# UNITED STATES PATENT AND TRADEMARK OFFICE

10/646,478

# Office Action Summary

### **DETAILED ACTION**

FIG. 7

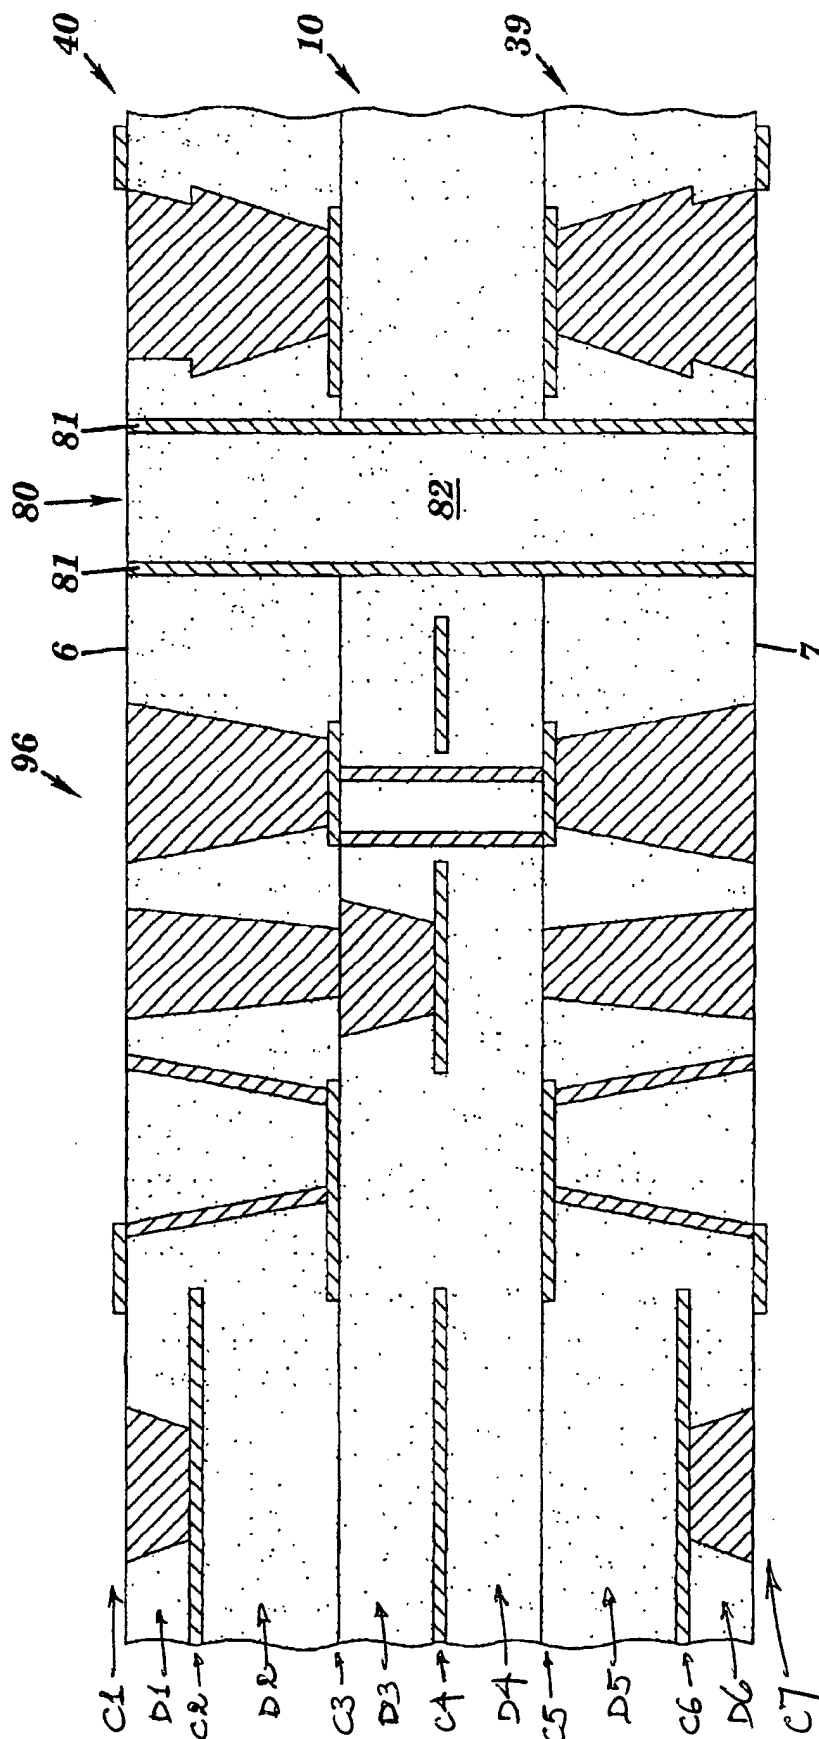
**Regarding claim 31**, Carpenter et al., in another embodiment of figure 7, (figure 7 with marked elements as shown in attachment "A"), discloses a substrate comprising:

a first conductive layer (C3) between a first dielectric layer (D2) and a second dielectric layer (D3), the first conductive layer including a first skip via (V1) extending through the first dielectric layer (D2) and a third dielectric layer (D1); and a second conductive layer on a fourth dielectric layer (D4), the second conductive layer including a second skip via (V2) extending through the second dielectric layer and the fourth dielectric layer (D4), the first skip via and the second skip via being stacked on top of one another (see figure 7, appendix A).

**Regarding claim 32,** Carpenter et al., further discloses the first skip via (V1) includes a longitudinal axis (longitudinal axis passing through via V1) and the second skip via (V2) includes a longitudinal axis (longitudinal axis passing through via V2), the longitudinal axis of the first skip via being substantially aligned with the longitudinal axis of the second skip via (see figure 7, appendix A).

**Regarding claim 33,** Carpenter et al., further discloses the first (D2), second (D3), third (D1) and fourth (D4) dielectric layers are formed on a core (D6) and the first (C3) and second conductive layers (C5) are formed on the core (D6).

**Regarding claim 34,** Carpenter et al., further discloses the second conductive layer (C5) is between the fourth dielectric layer (D4) and a fifth dielectric layer (D5).

**Regarding claim 37**, Carpenter et al., further discloses the first conductive layer is a patterned conductive layer and the second conductive layer is a patterned conductive layer (see figure 7, appendix "A").

**Regarding claim 35**, Carpenter et al., discloses all the features of the claimed invention, as applied to claim 35 above, the embodiment of figure 7 (elements marked on figure 7 in attachment "A"), including a third conductive layer (C6) on the fifth dielectric layer (D5), a third via (V3) extending through the fifth dielectric layer, the third via (V3) being stacked onto the first skip via (V1) and the second skip via (V2).

**Regarding claim 36**, Carpenter et al., further discloses the first (V1) and second (V2) skip vias each include a longitudinal axis (axis passing longitudinally through the vias) and the third via includes a longitudinal axis (axis passing longitudinally through the via), the longitudinal axis of the first skip via being substantially aligned with the longitudinal axis of the second skip via and the longitudinal axis of the third via (see figure 7, appendix "A").

**Regarding claim 38**, Carpenter et al., discloses all the features of the claimed invention, as applied to claim 31 above, in the embodiment of figure 7 (with the elements as marked on figure 7 in attachment "A") including the second skip via (V2) as a cylindrical via, but does not disclose the first skip via as a cylindrical via. Also, Carpenter et al., is silent about the diameters of both the vias. However, as can be seen
